AGENDA PORTLAND PLANNING BOARD MEETING

Memorandum
Planning and Urban Development Department
Planning Division

To: Sean Dundon, Chair and Members of the Portland Planning Board
 From: Shukria Wiar, Planner
 Date: October 15, 2019
 Re: Birch Meadow Apartments, 6 White Birch Lane, Birchlane, LLC
 Project #: PL-000570-2019 CBL: 437 A046, 343 D016
 Meeting Date: October 22, 2019

6 White Birch Lane PRUD, Portland, Maine
Response to Comments

**08 Existing Conditions REV - CCTV.pdf**
1116K

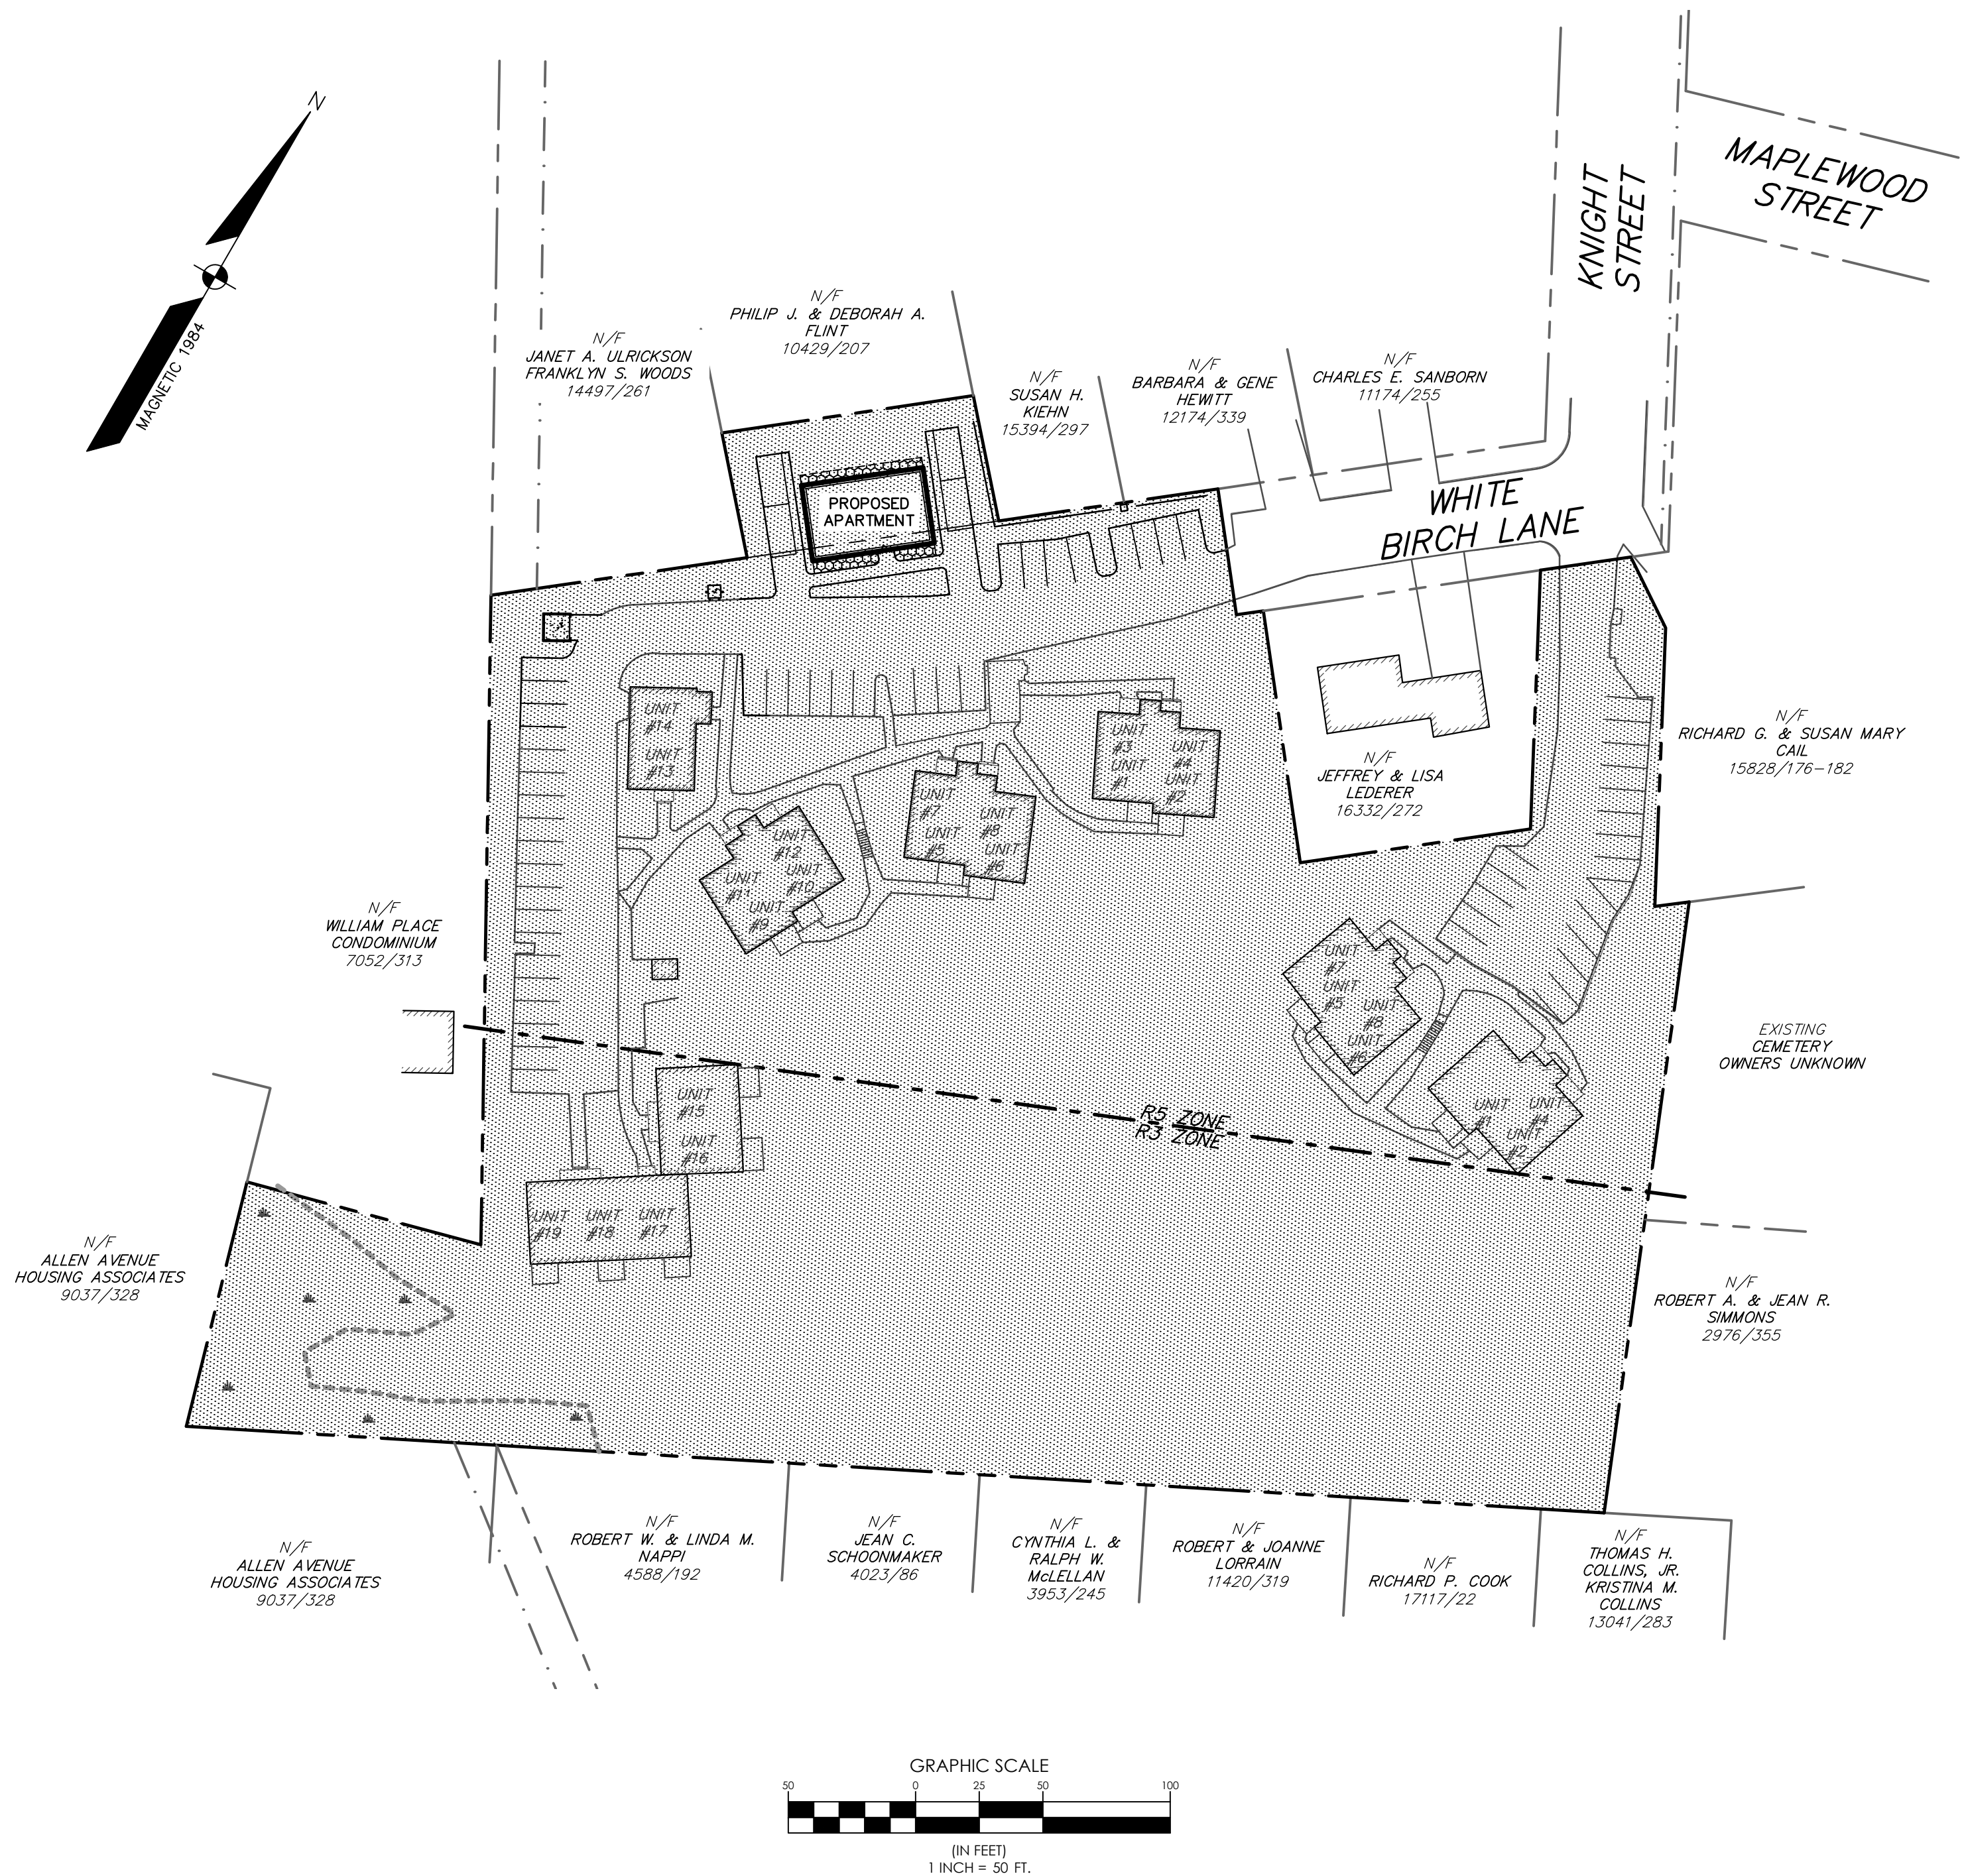
The Applicant has provided copies of communications with the City of Portland regarding the inspection and verification of existing sewer and storm drain systems; the Applicant should clarify the status of this work and whether the Existing Conditions plan has been updated to reflect the results of the inspections.

The applicant needs to update the existing conditions to show the connection between the two sewer lines behind the buildings. The current plans just asterisks where they believe the sewer is but they do not show the size or length of pipe connecting. I will send over a pdf showing what I am talking about shortly.

See attached plans. Note that "6 White Birch Ln Plan+aerial2" shows the investigation map superimposed on the aerial photo. Doug drew in the existing sewer man hole and sewer in green to call attention to the fact that the investigation map is a little off. Then connection from the existing sewer man hole #1 to the sewer between the two SMH3s is not shown on any existing conditions plan nor is the pipe size or material included. The applicant needs to transfer the information found from their investigation into the existing conditions maps so we have the correct information for our files.

SHEET 3 OF 8

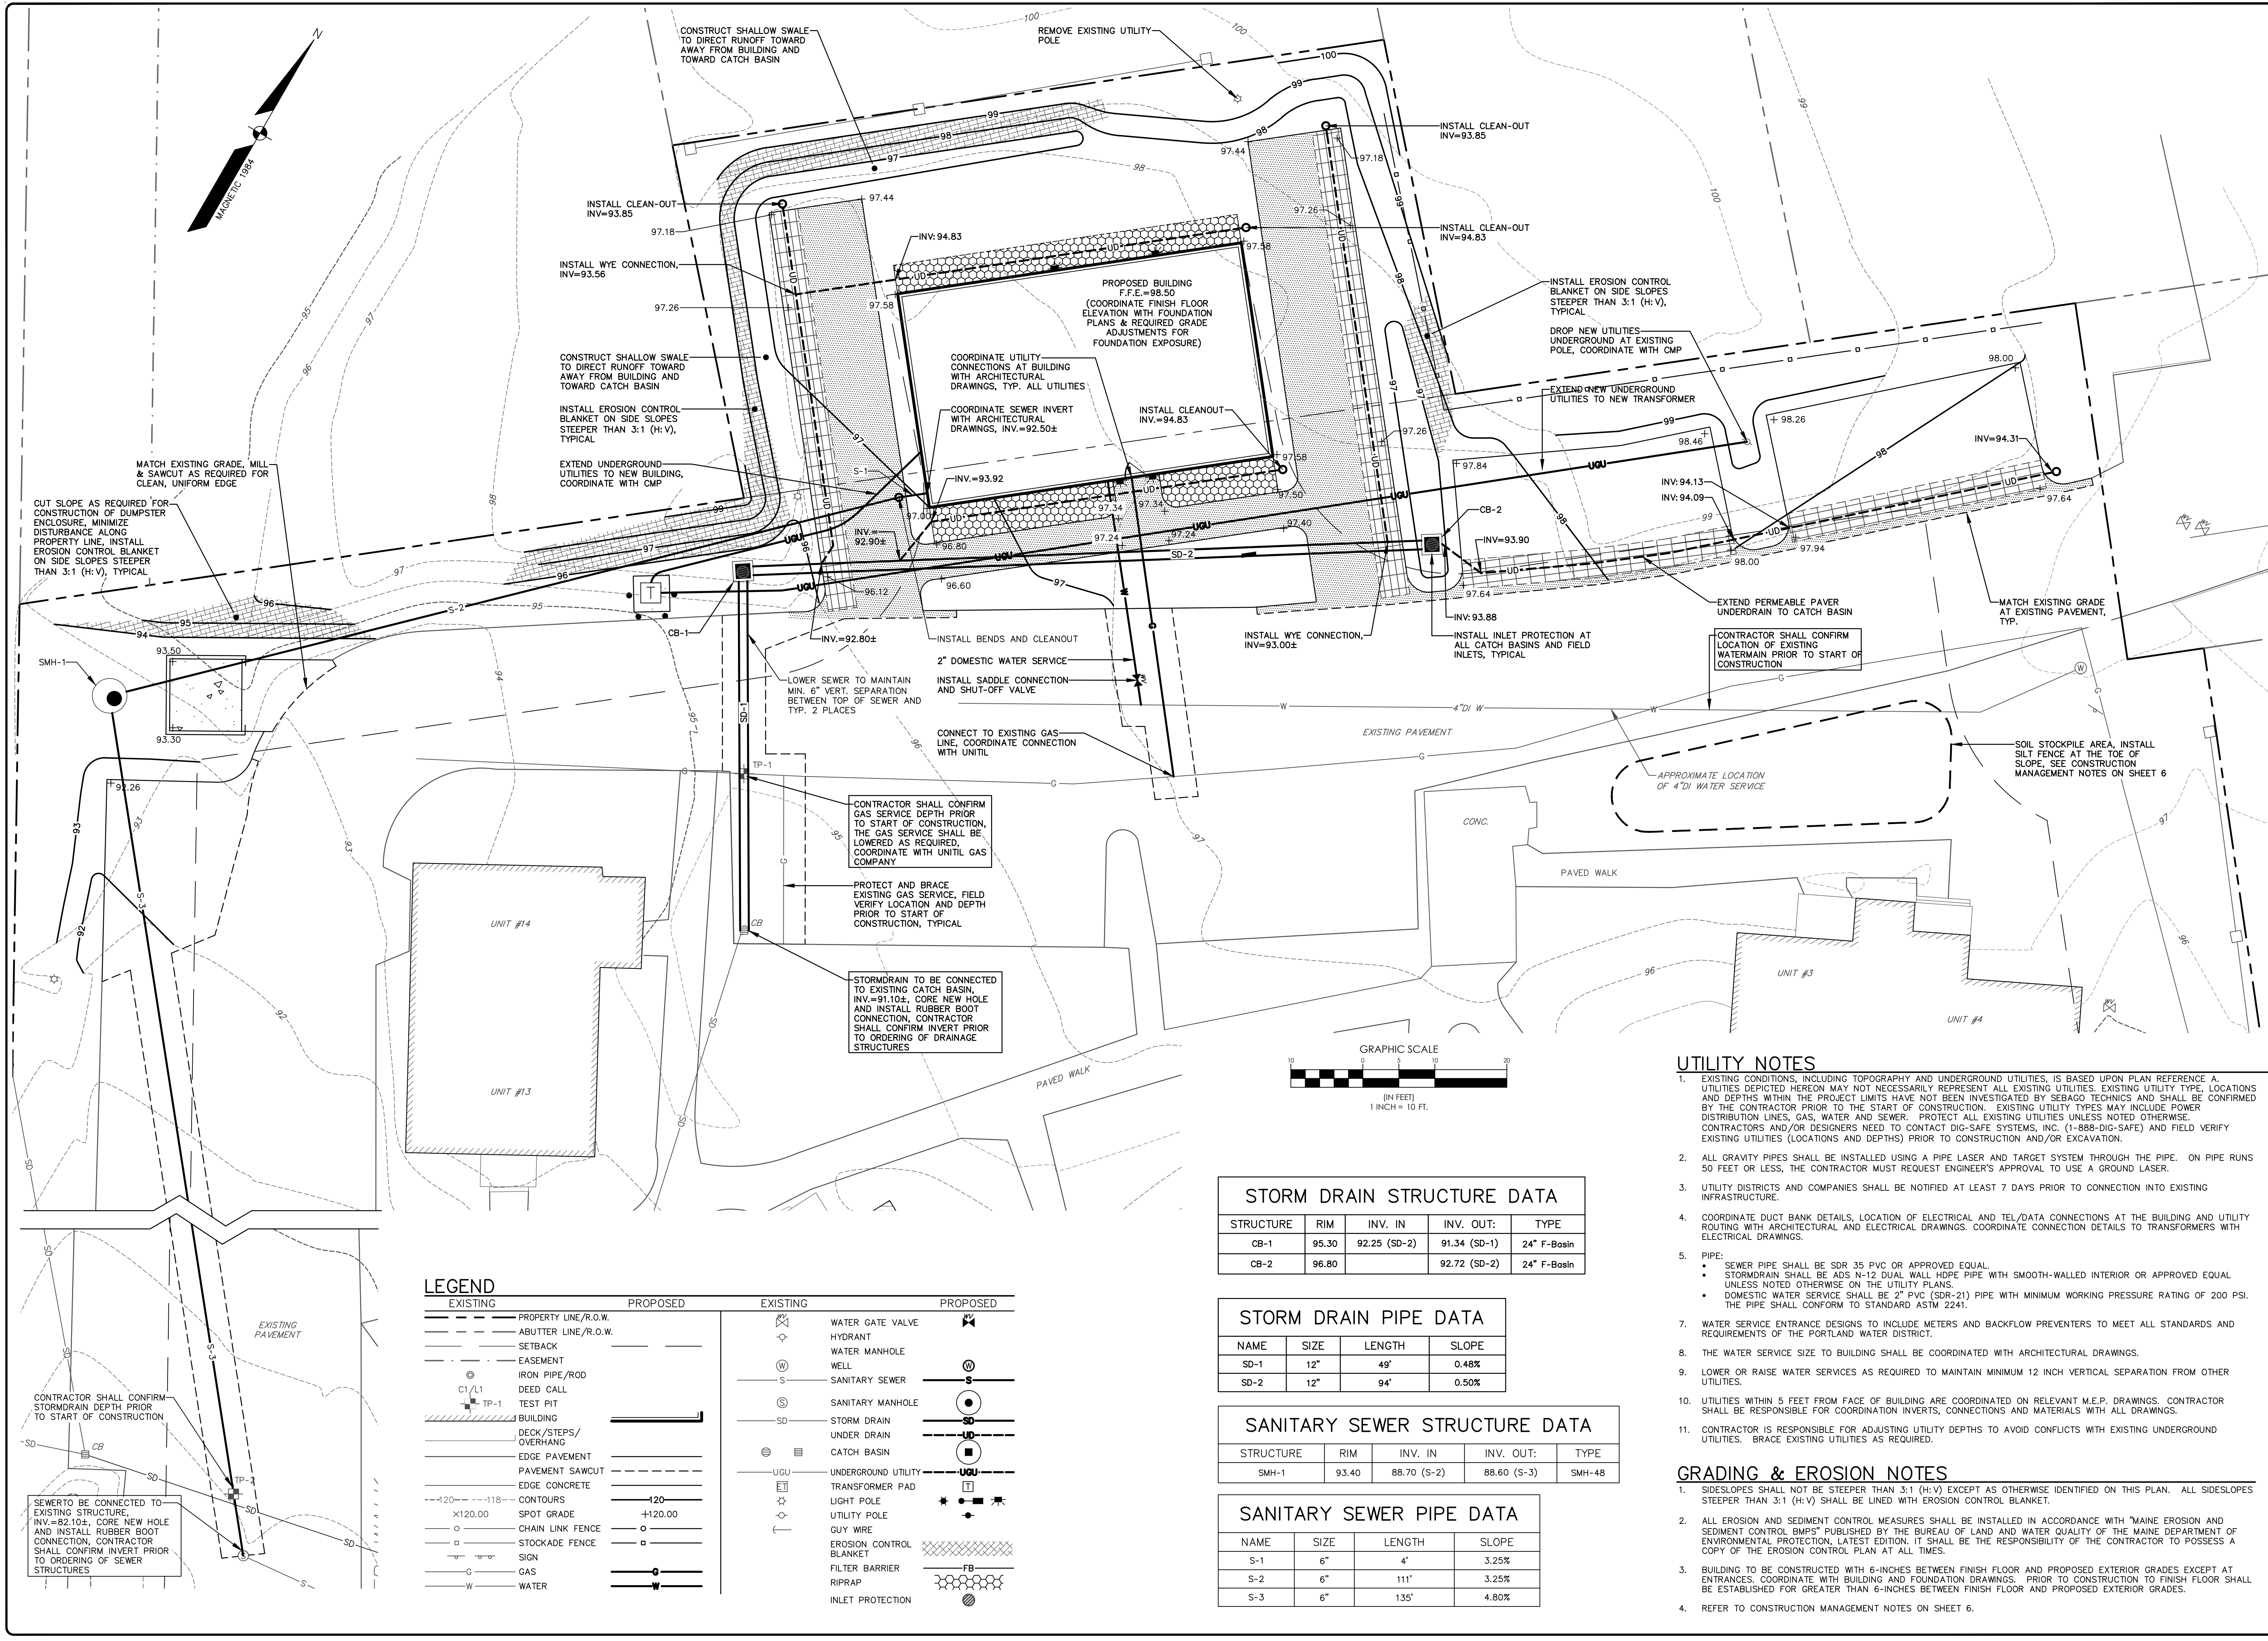
Response: The Site Plan (Sheet 3) depicts snow storage areas in the general vicinity of the new multi-unit dwelling and other surrounding site improvements.

Response: The Site Plan (Sheet 3) was revised to add landscaping and fencing so that external buffers are enhanced between the new surface parking and the neighboring residential properties.

Response: The Site Plan (Sheet 3) was revised to add landscaping near the dumpster enclosure and transformer so that screening is provided by these units and apartment units. A narrow strip of pavement was eliminated between the building and parking to provide a 3-foot wide planting bay.
